Subject: Issuance of Amendment No. 28 to Facility Operating
License NPF-21 - WPPSS Nuclear Project No. 2

Amendment No. 28
License No. NPF-21

ENCLOSURE TO LICENSE AMENDMENT NO. 28

Figure 3.2.1-1

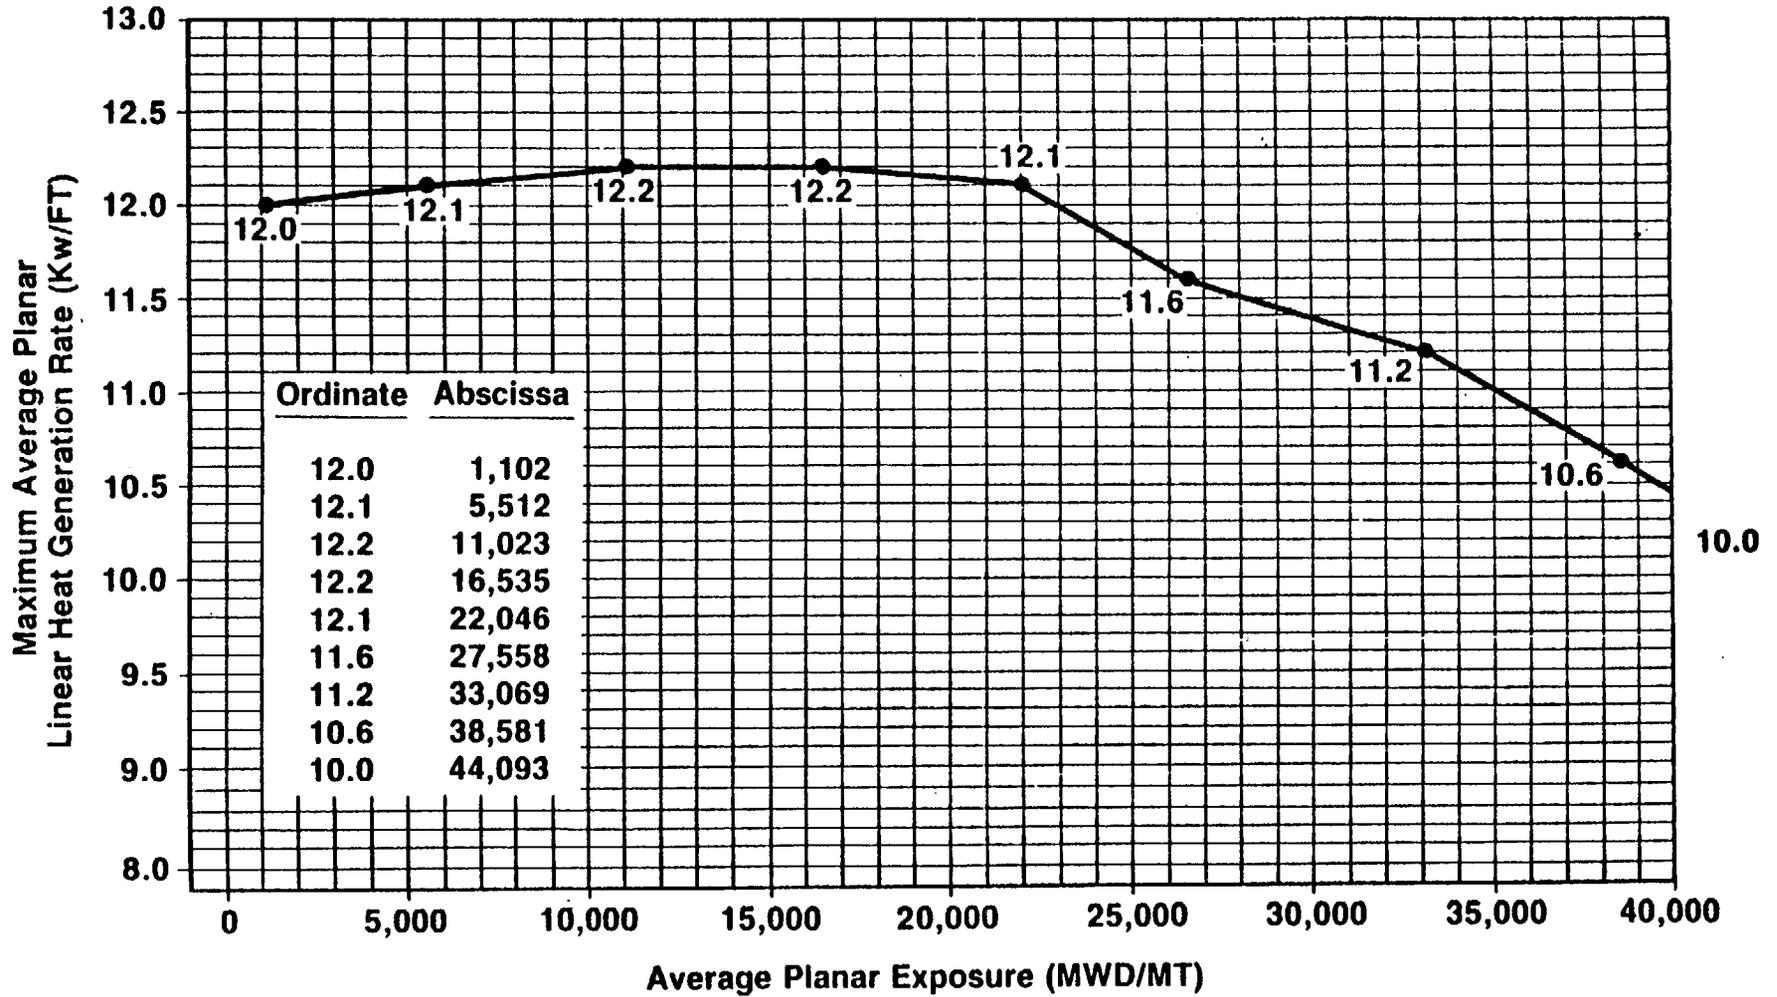
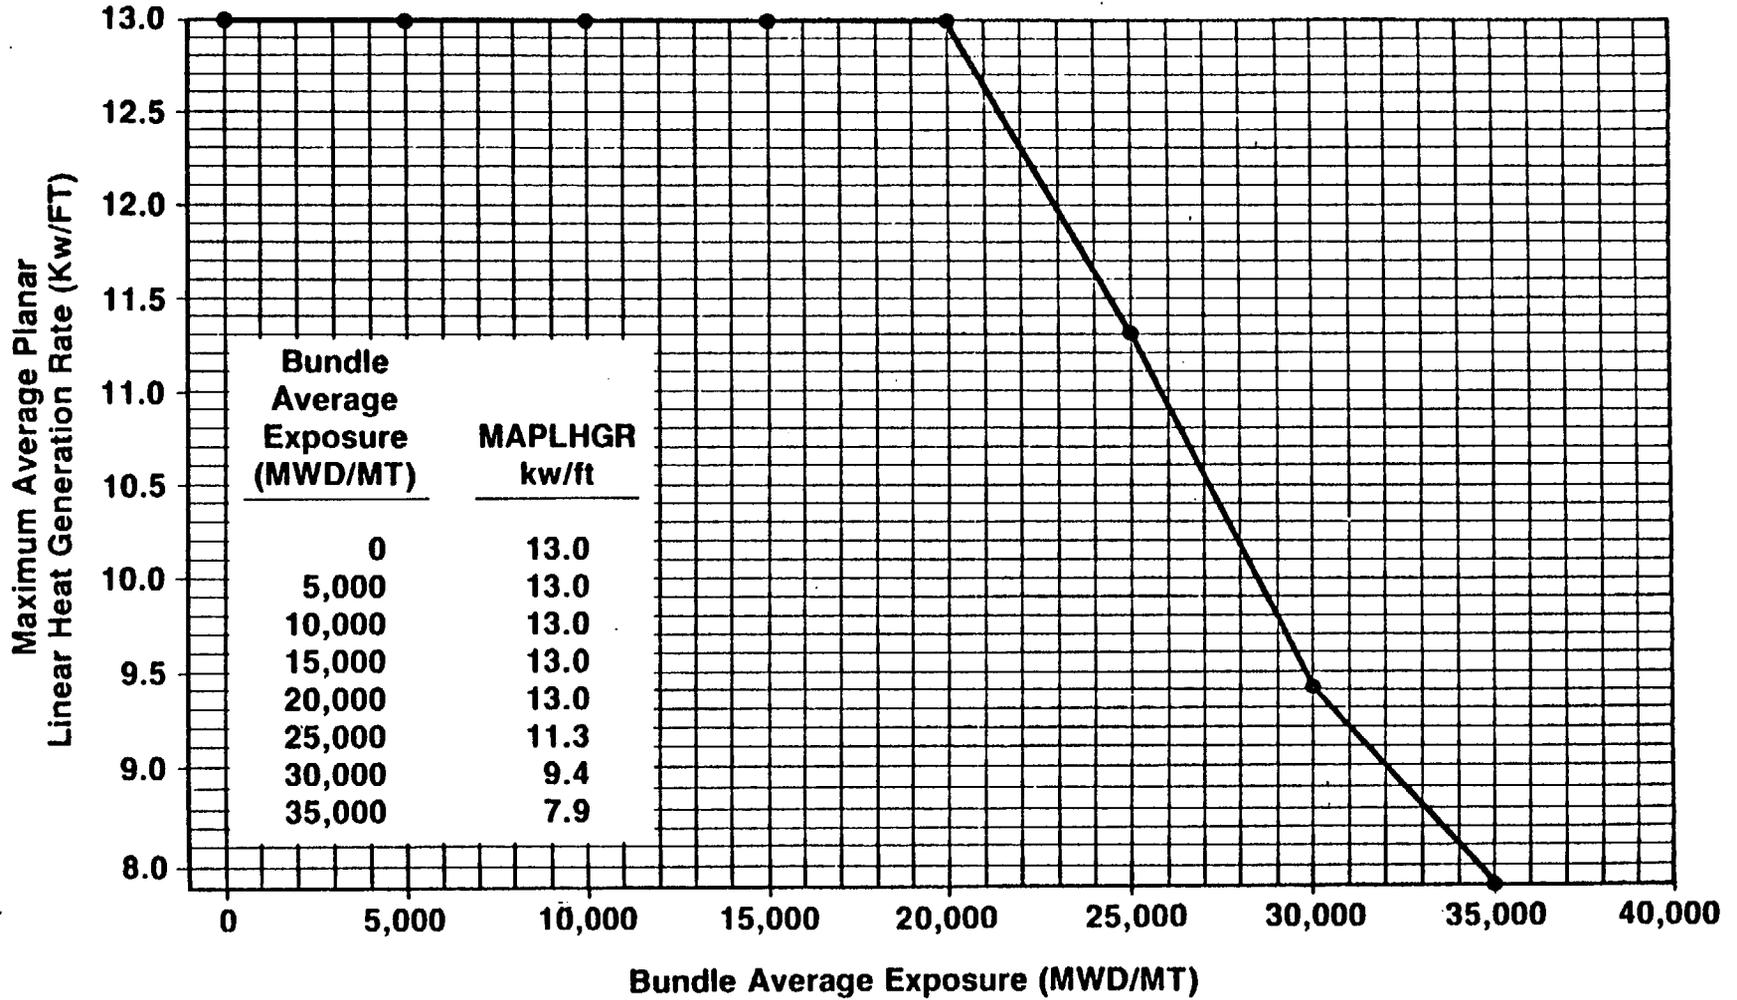
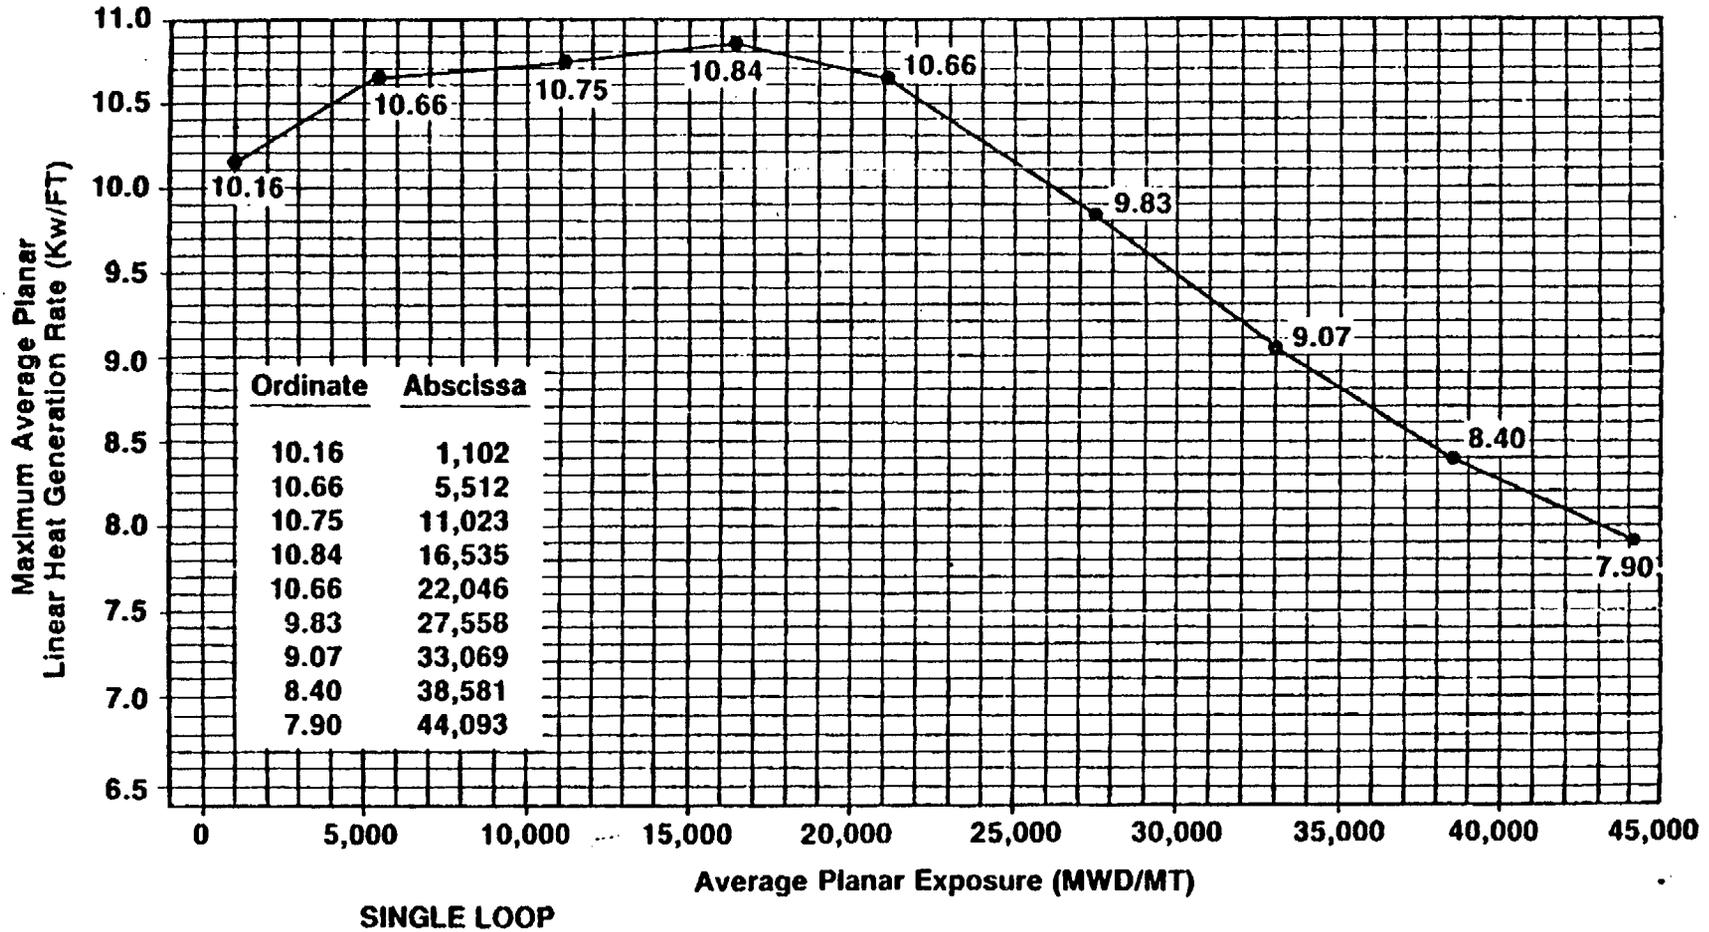
- (4) 3.2.1, and Figures 3.2.1-1 through 3: This is a change to the use of the Exxon definition of Average Bundle Exposure for Exxon fuel and the transfer to metric units for GE fuel burnup. A MAPLHGR curve is added for the XN-1 fuel and the curve for unused low enrichment GE fuel is removed. These are acceptable changes.

Figure 3.2.3-1

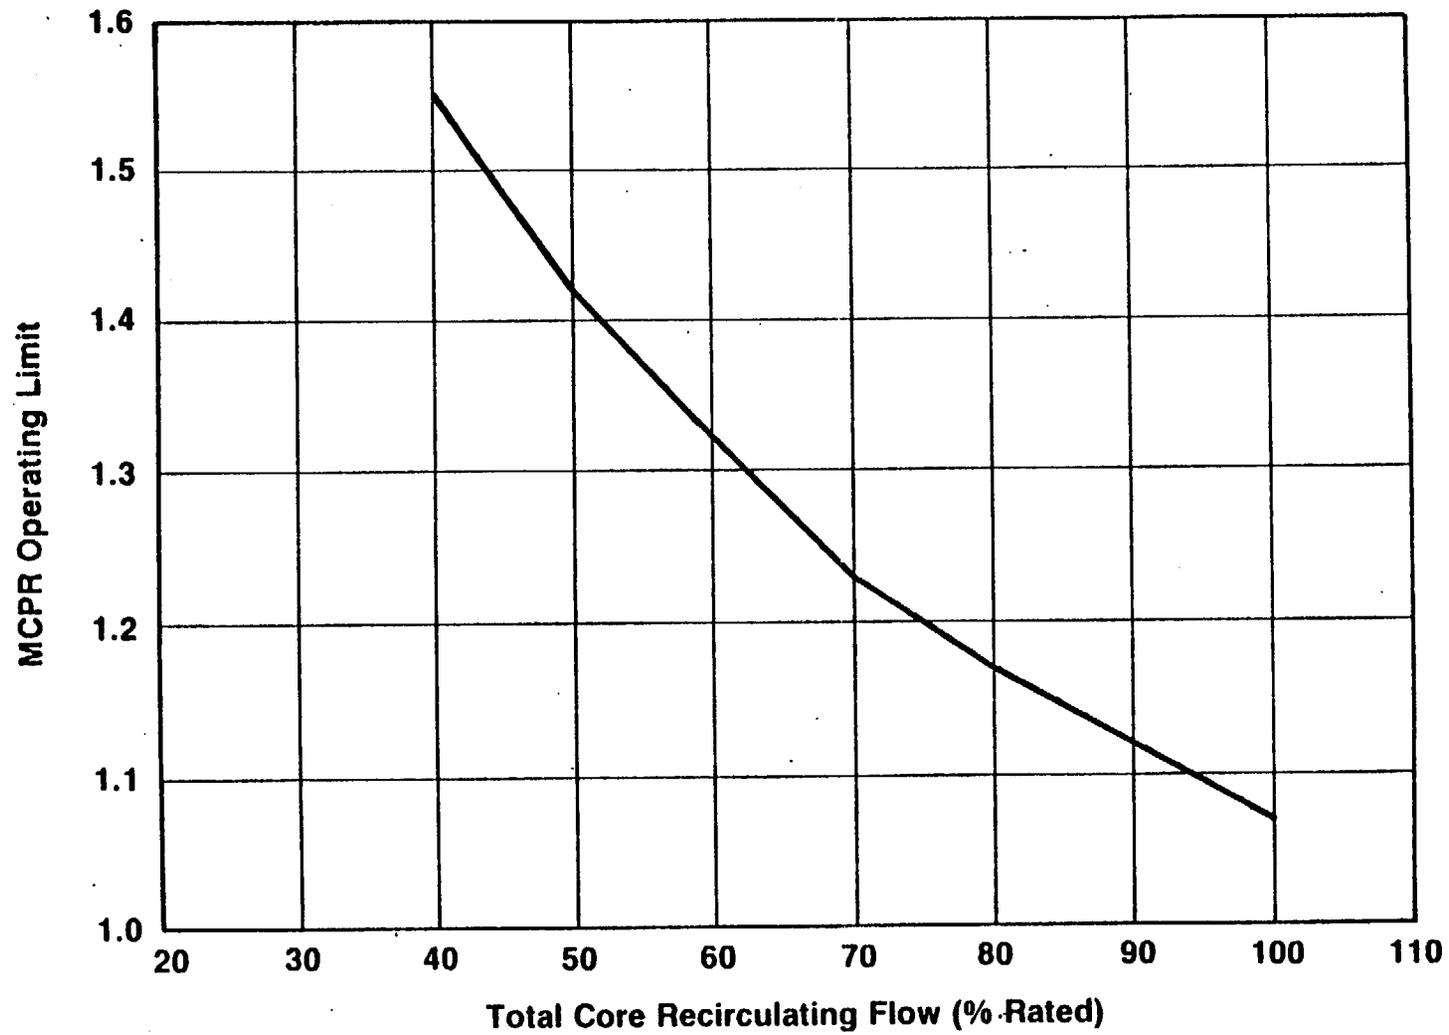
- (5) 3/4.2.3 plus Table 3.2.3-1 plus Figure 3.2.3-1: This change removes the elements of the GE methodology for determining MCPR limits, including the K_f function, and replaces them with the results of the Exxon methodology and analyses for N2C2. The new MCPR limits are principally single value functions of (1) GE or Exxon fuel, (2) Scram time, (3) RPT operability and (4) Core flow. MCPR is limited, for reduced flow operation, as given in the figure. As previously discussed these values are the results of Exxon's calculations of transients and are primarily controlled by the RWE and LRWB. The values to be used for Table 3.2.3-1 are not those of the original submittal, but those of Reference 7 from analyses using the revised loading parameters. "Normal" scram time is defined in this specification, including the time to standard notches and surveillance is referenced to the existing surveillance specification of 4.1.3.1. These changes are acceptable.

Figure 3.2.4-1

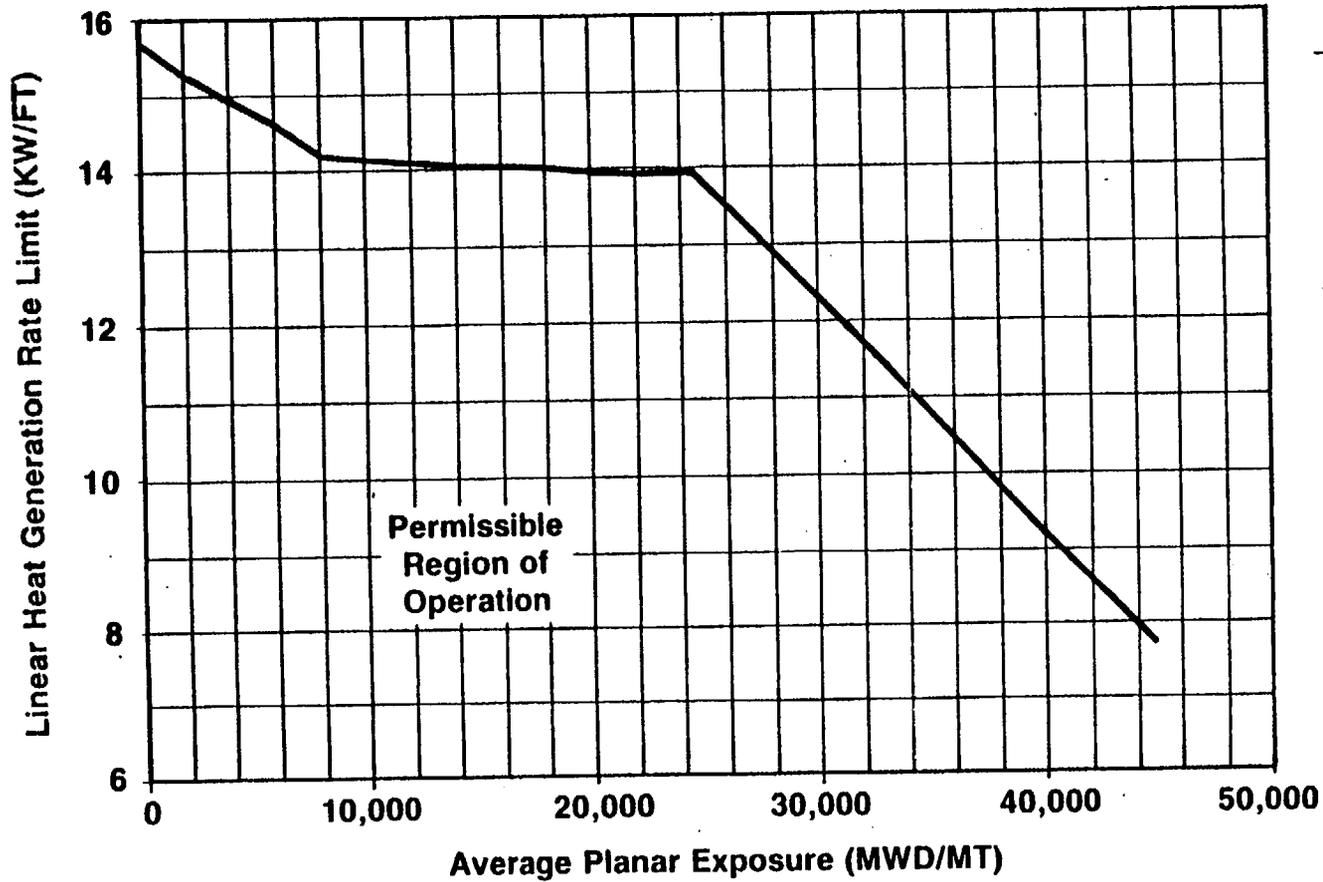
- (6) 3.2.4 and Figure 3.2.4-1: A LHGR for the Exxon XN-1 fuel is added to this specification. As was previously discussed, this type of specification and figure giving LHGR as a function of burnup was added to the Susquehanna 1 specification as a result of staff discussions with Exxon. This addition to the WNP-2 specification is also acceptable.
